Case for changing the CCMA for the area east of the River Sid and Sidmouth East

The following is taken from East Devon Local Plan – Topic Paper – CCF- 005
Adaptation and Resilience to Climate Change: Coastal Change **Yellow highlighted**
for information relevant to East Beach.

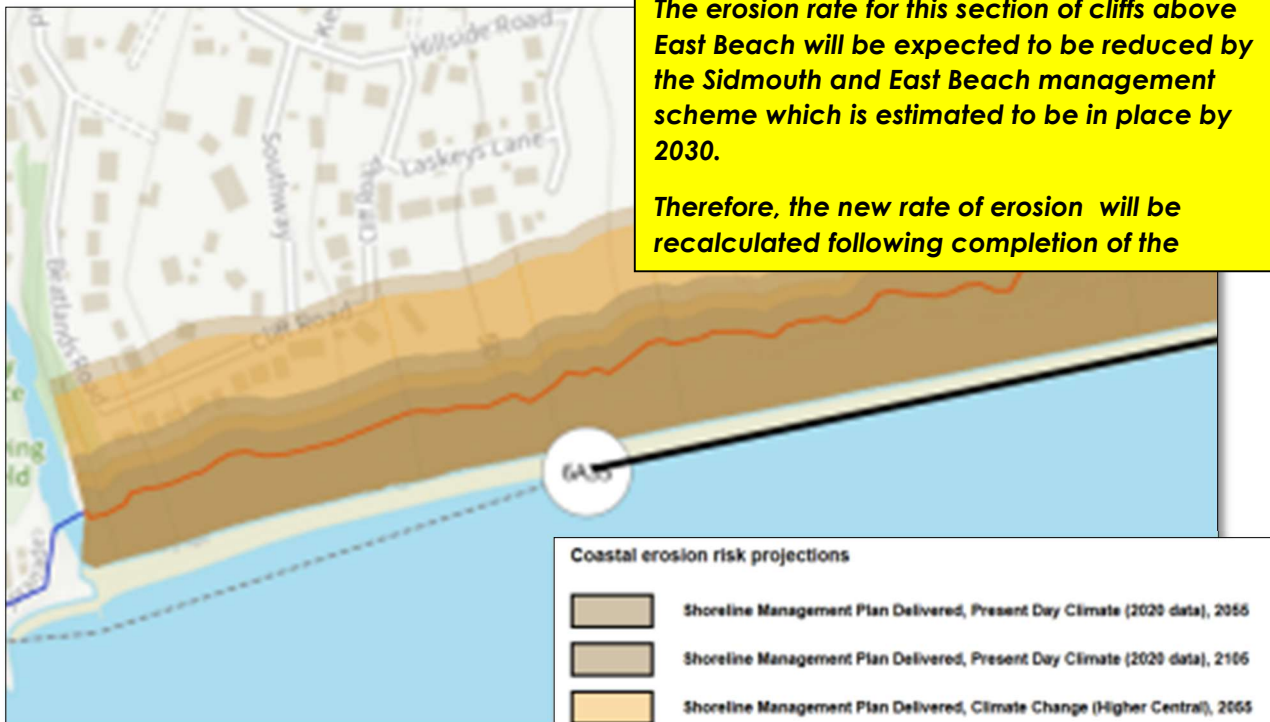
However, as the final design and specification for the BMP/BMS has not yet been designed or its effect determined it would be premature to quantify the erosion rate at this point.

Therefore because of new, as yet unknown factors that will only become apparent once the Sidmouth and East Beach project is finalised, the projected erosion rate is unable to be estimated accurately, and the estimation using the "worst case" scenario would be unjustified.

Map 34

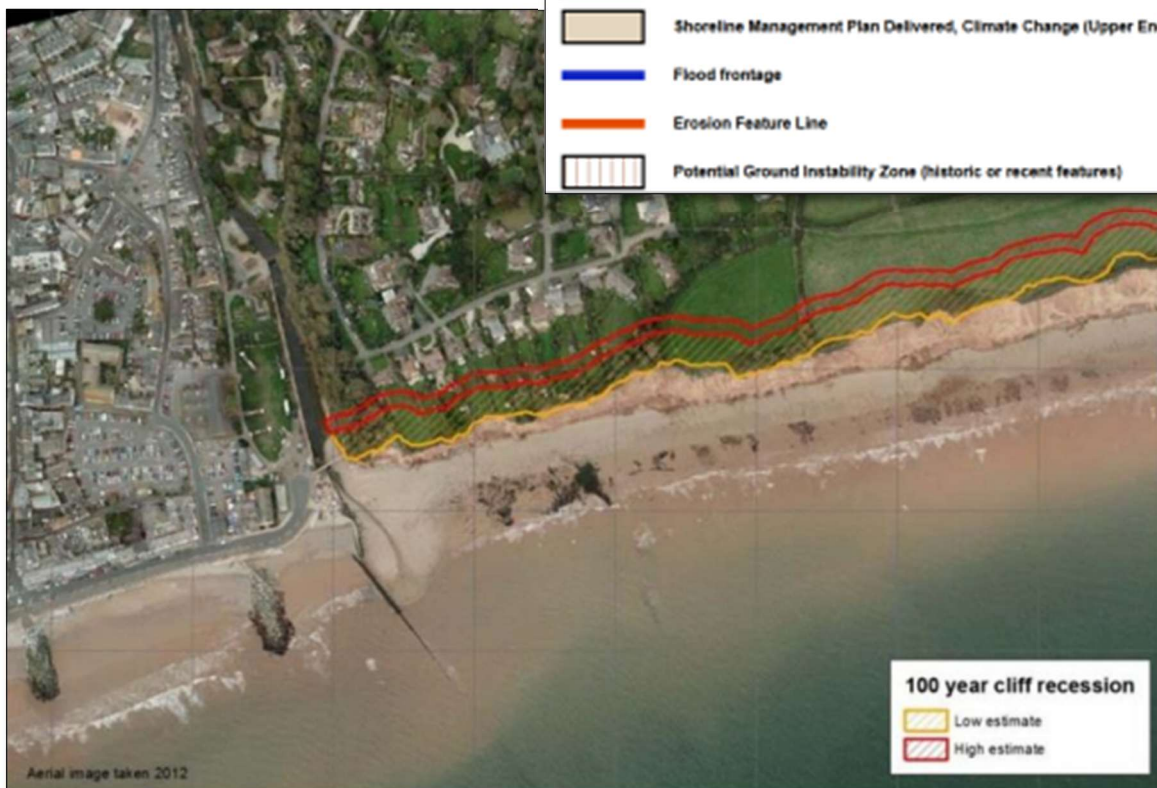
4.7 Most recently, the SMP's have been updated with maps that show the new National Coastal Erosion Risk Mapping (NCERM), which provides the most up to date national picture of coastal erosion risk for England. The relevant map 34 shows the coastal erosion risk projection climate change (upper end), 2105 to be very similar to that of the Sidmouth BMP OBC (see appendix A for plans from various sources that show differing erosion rates). This provides further evidence to justify the reduction in the size of the CCMA to the east of the River Sid in the Regulation 19 local plan.

The solution is to either not include any defined line or use the BMP OBC line but with a "health warning" that this is not yet conclusive line.

See maps on following page with yellow health warning

Therefore, some note of caution needs to be inserted to provide clarity and guidance
